ADDENDUM NO. 3

ISSUE DATE	
CD	12/3/20
2. ADDENDUM 3.	02.18.21
UNIVERSITY OF SOUTH CAROLINA COLUMBIA, SC Project # 50003366-2 FACILITIES RELOCATION - ARCHITECTURAL RENOVATION - 1ST FLOOR ARCHITECTURAL	
DRAWN BY: JHM CHECKED BY: JHM

REFLECTED CEILING
PLAN - MECHANICAL
REFERENCE

A2.1M

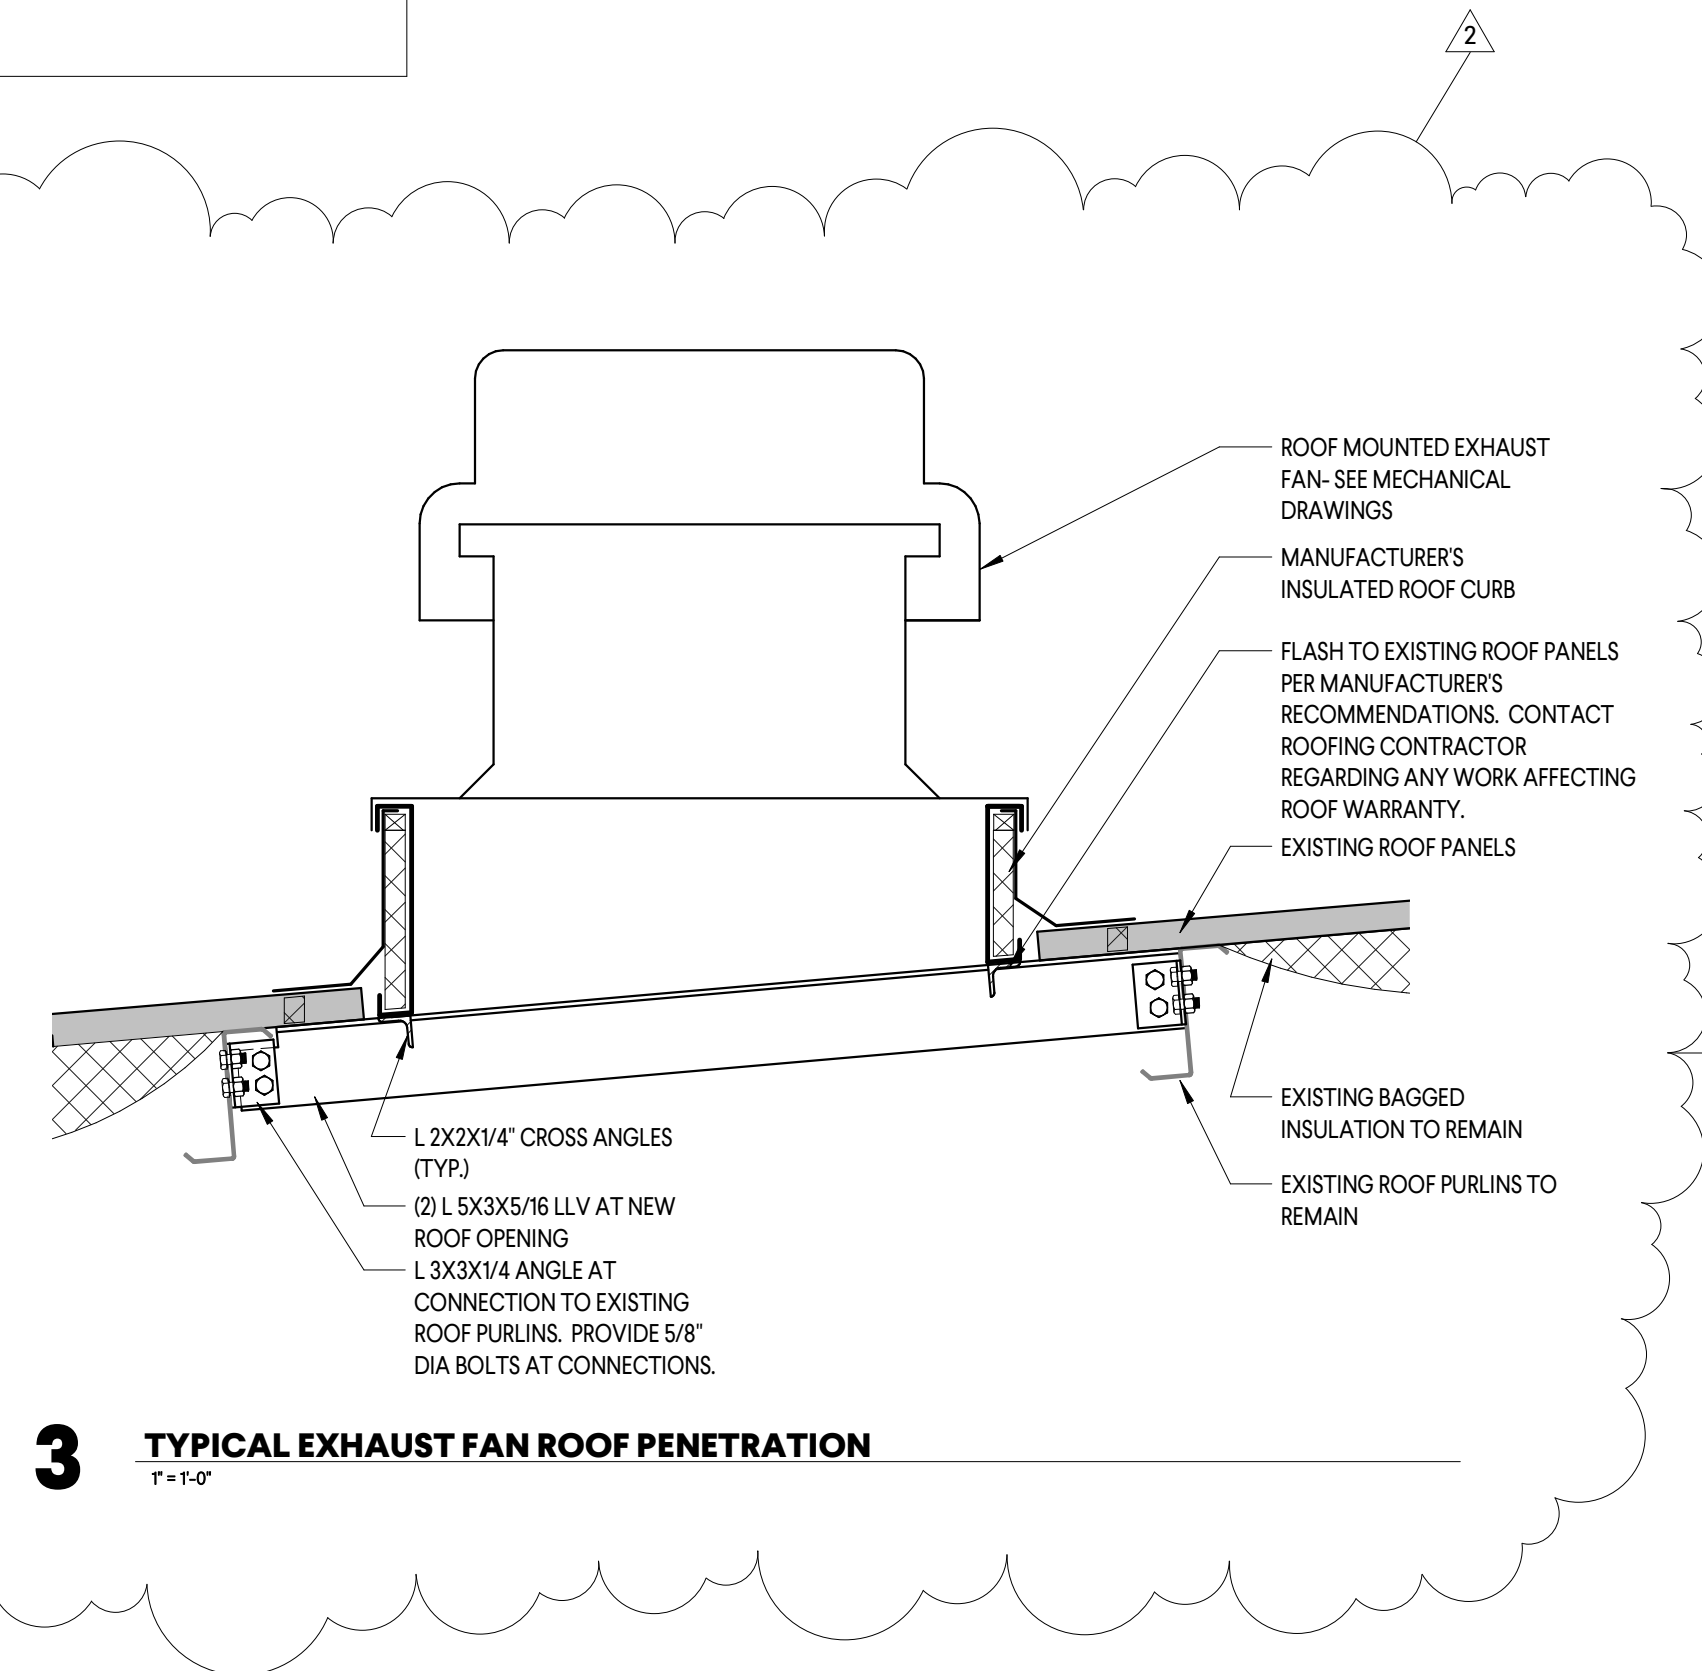
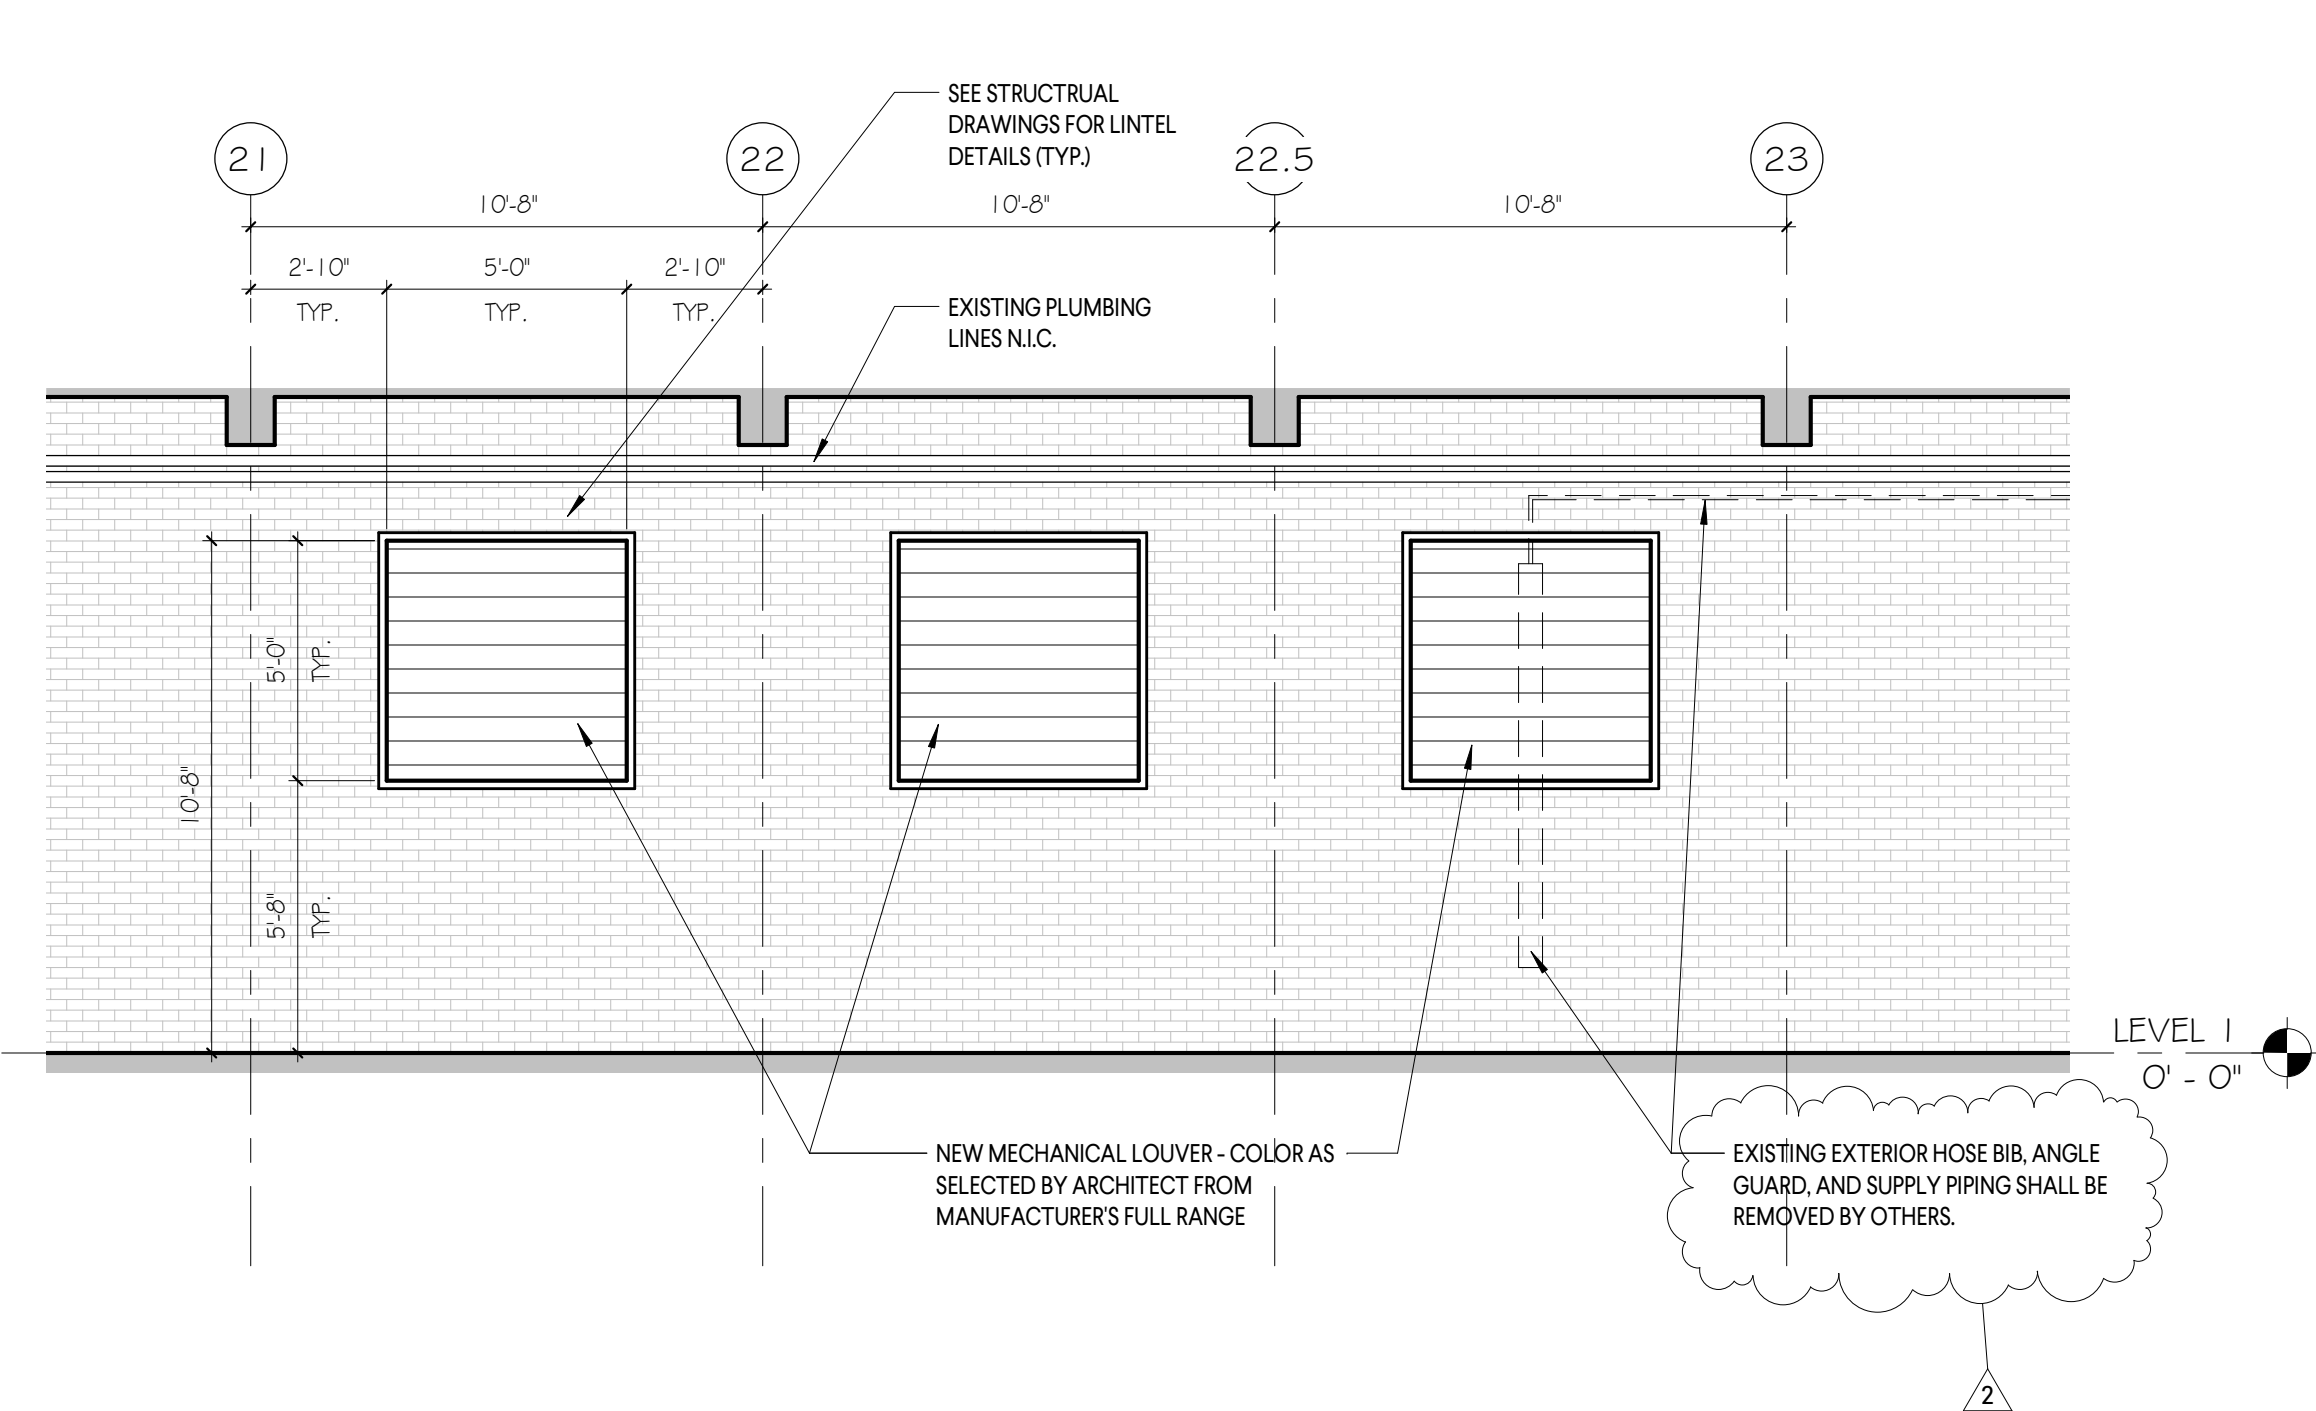
1. Replace Sheet A2.1M with the attached and note clouded revisions.
2. Sheet 1-M-101A: Note where ducts from DX-VAV-3 enter the building there is existing wall mounted fiber conduit. See attached photo. Contractor shall install new ductwork and penetrations around existing conduit and shall not interrupt existing fiber service to building.
